CITY OF ALLENTOWN

RESOLUTION

R97 – 2022

Certificates of Appropriateness for work in the Historic Districts:

Aerial of Roof (Applicant)**Primary Facade from Neighboring Building, 1015 Oak St. indicated with arrow (Applicant)****Oak Street Facade (Google Street View, 2019)****Applicable Guidelines:****3.10 Solar Energy and Energy Improvements**

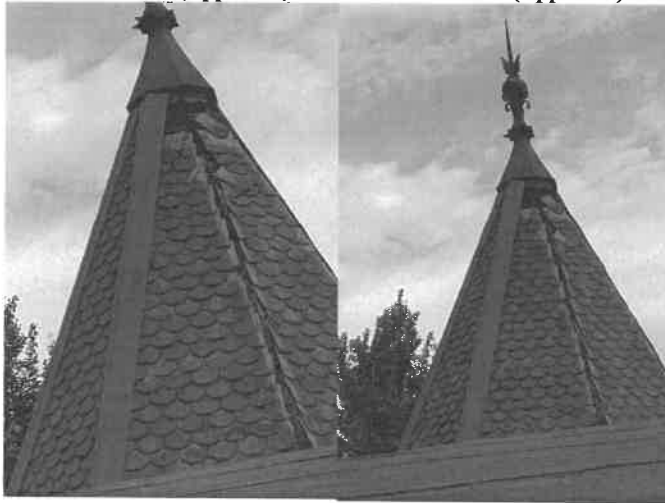
At the two upper story roofs, the proposed arrays comply with the Guidelines. It appears they will have minimal visibility due to the height of the building. The six-panel array at the entry porch will be clearly visible from the street and does not comply with Guideline 3.10.3. It is noted that the primary facade of this building faces onto Oak Street, which is a smaller secondary street. All wiring, conduits, and meters are recommended to be concealed as much as possible and painted to blend into the wall on which they are mounted.

AJ and GL state the location of the panels at the lowest, first floor roof (shown in the green square in presentation materials) are in a location that is visible and not consistent with the Guidelines. Asked Applicant if they could relocate the six panels at the lowest roof or be removed. Applicant clarified that the two upper roofs are full. Discussion that HARB could approve either choice of removal or relocation by Applicant.

1. Installation of roof-mounted solar panels at the two (2) upper roofs, as submitted.
2. No solar panels shall be installed on the lowest, first floor roof. The six (6) panels on the lower roof as submitted shall be relocated to the upper roofs or removed from design as agreed.
3. Solar panels shall be 4" to 6" from the surface of the roof and be set 3' from the roof edge as submitted.
4. Inverter and disconnect box will be installed next to PPL meter as per regulation, as submitted. Equipment may be painted to blend into the wall surface or otherwise concealed.
